**CITY OF FERNDALE
WASTEWATER TREATMENT PLANT UPGRADE**

**ADDENDUM NO. 4 (9 pages total)
Issue Date: January 3, 2020**

SHEET A0.01

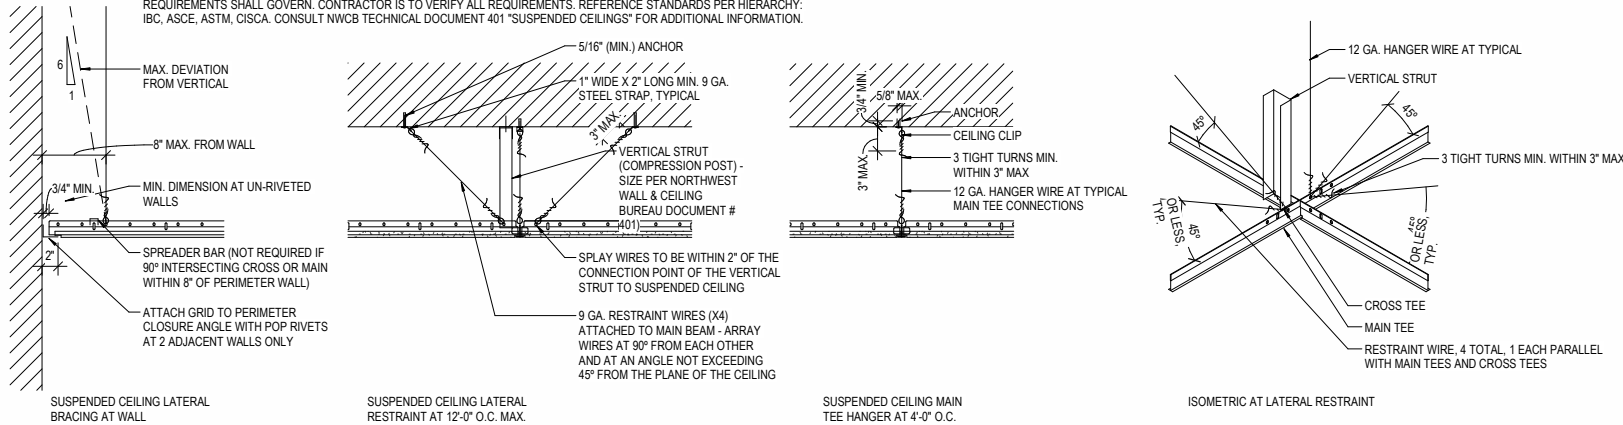
- **CLARIFICATION:** Roofing section R2 shall also include the joists, hangers, and hardboard ceiling shown on S5.04. Hardboard shall be James Hardie Commercial HardiePanel. Dimensions: 4'x8'. Thickness: 5/16". Weight: 2.3 lbs/sqft. Texture: Smooth. Finish/Color: Primed.
